MIL-M-28787/421
AMENDMENT 1
29 September 1993

MODULES, STANDARD ELECTRONIC

NATO-STD-4156(MODIFIED) CHANNEL CONTROL MODULE, KEY CODE ATK

This amendment forms a part of Military Specification MIL-M-28787/421, dated 17 May 1991, and is approved for use by all Departments and Agencies of the Department of Defense.

FIGURE 11a. Dynamic waveforms for table XVII.

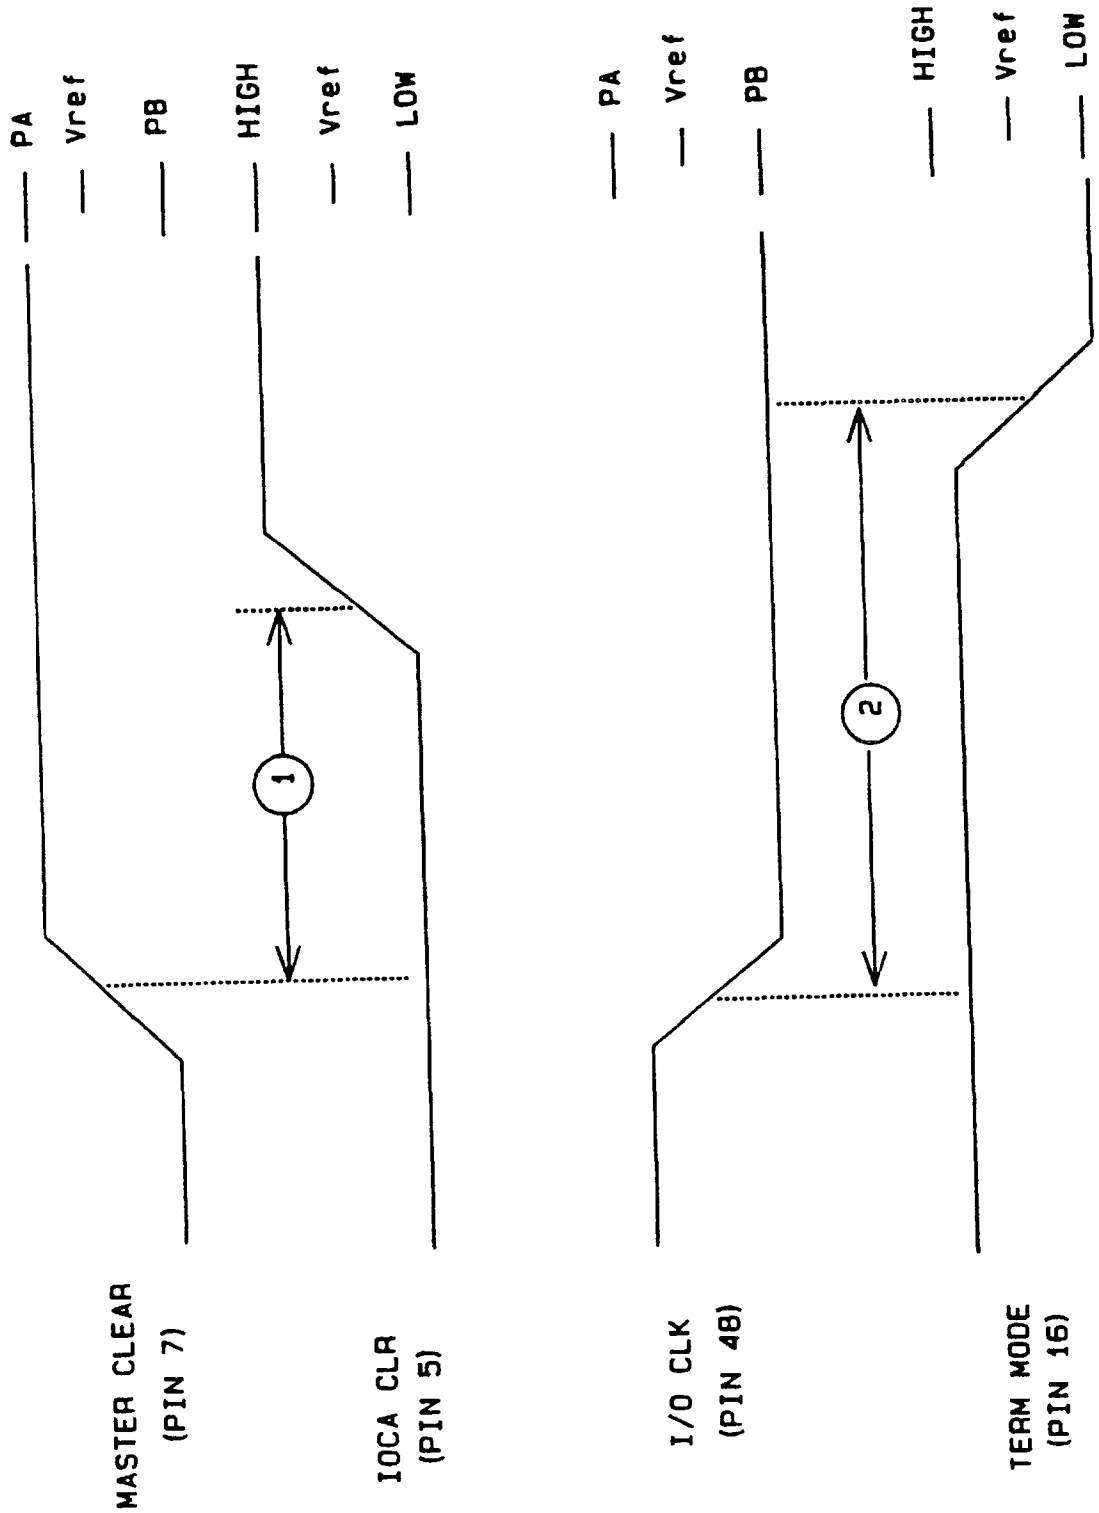
FIGURE 11a: Delete and substitute new figure 11a as printed on page 4 of this amendment.
